Access Compliance Report

Public Rights-of-Way

(Curb Ramps)

Intersection ID: 47881	Main Street: PINEHAVEN_CT	Cross Street: PLAZA_MEADOW_DR	Location: SW
ADA ID: C03F81AE13C4	Ramp Type: PerpDiag	Initial Pass/Fail: Fail	Overall Compliance: No
Severity Score: 8.75			
Codes/Mitigation Info/Possible Solution		Field Measurements/Component Compliance

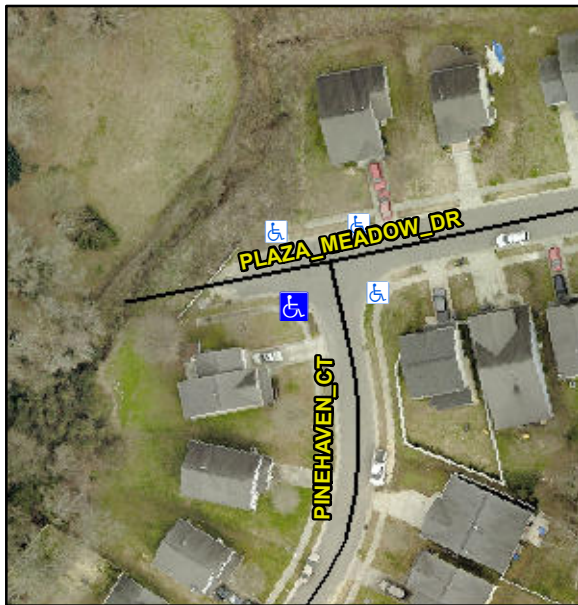
Not Found, R304.5.1

Compliance	Description	Data	Compliance	Description	Data
N/A	Ramp Length (in)	44.0	Yes	Ramp Slope (%)	6.3
No	Ramp Width (in)	46.5	Yes	Ramp XSlope (%)	0.1
N/A	Flare Type LT	N/A	N/A	Flare Type RT	N/A
N/A	Flare Slope LT (%)	N/A	N/A	Flare Slope RT (%)	N/A
N/A	Flare Traversable LT?	N/A	N/A	Flare Traversable RT?	N/A
N/A	Landing Length (in)	N/A	N/A	DWS Provided?	N/A
N/A	Landing Width (in)	N/A	N/A	DWS Contrast?	N/A
N/A	Landing Slope (%)	N/A	N/A	DWS Length (in)	N/A
N/A	Landing X Slope (%)	N/A	N/A	DWS Full Width?	N/A
N/A	Landing Curb? (Y/N)	N/A	N/A	DWS Offset (in)	N/A
N/A	Shared Landing?	N/A			
N/A	Gutter Ponding?	N/A	N/A	Gutter Slope (%)	N/A
N/A	Gutter Lip Ht (in)	N/A	N/A	Gutter X Slope (%)	N/A
N/A	Painted X Walk1?	No	N/A	Painted X Walk2?	No
	X Walk 1 Direction	To E		X Walk 2 Direction	To N
N/A	X Walk 1 Width (in)	N/A	N/A	X Walk 2 Width (in)	N/A
	X Walk 1 Slope (%)	1.1		X Walk 2 Slope (%)	2.2
	X Walk 1 X Slope (%)	1.9		X Walk 2 X Slope (%)	2.7

Remove & Replace Curb Ramp With Two New Directional Ramps or Equivalent.
